Seqwater – Response to Mr Babister's report

**Comments on “Review of Hydraulic Modelling Final Report” prepared by
WMAwater for Queensland Flood Commission of Inquiry, July 2011**

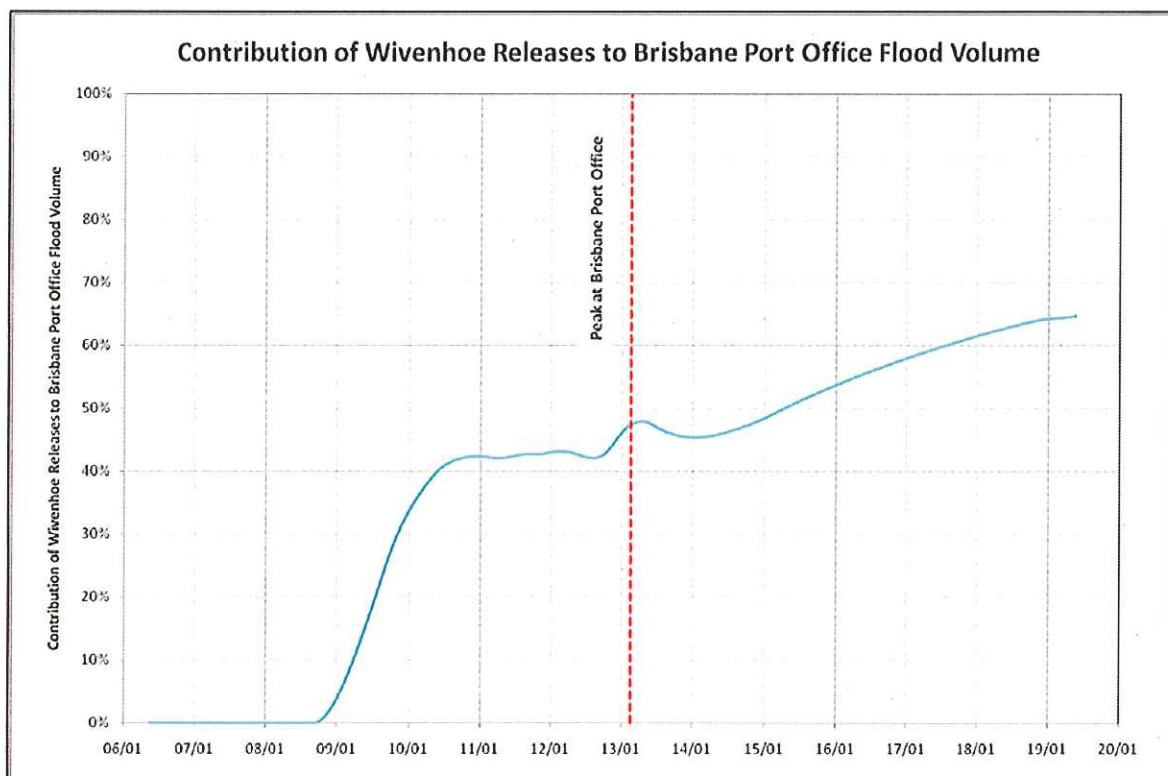
1. It has been suggested in Mr Babister's report that the total volume discharged from Wivenhoe Dam between the 09/01/2011 and 16/01/2011 was 59% of all the flow volume in the lower Brisbane River.
2. This figure overestimates the contribution of Wivenhoe because it ignores the travel time between Wivenhoe Dam and Brisbane Port Office.
3. Typically flood water takes approximately 27 hours to reach the Port Office from Wivenhoe.
4. Between 06/01/2011 09:00 and 13/01/2011 03:00, the time of the peak at the Brisbane Port Office, the estimate flood volume at the Port Office was about 1,700,000ML.

5. Twenty seven hours prior to this time, the volume released from Wivenhoe was only 860,000ML, just below 50% of the total at Brisbane Port Office as indicated on the figure below.

6. By the end of the event, the Wivenhoe releases amounted to 2,650,000ML of the total of estimated total of nearly 4,000,000ML at the Port Office gauge, equivalent to about 65% of the total flood volume at the Port Office.
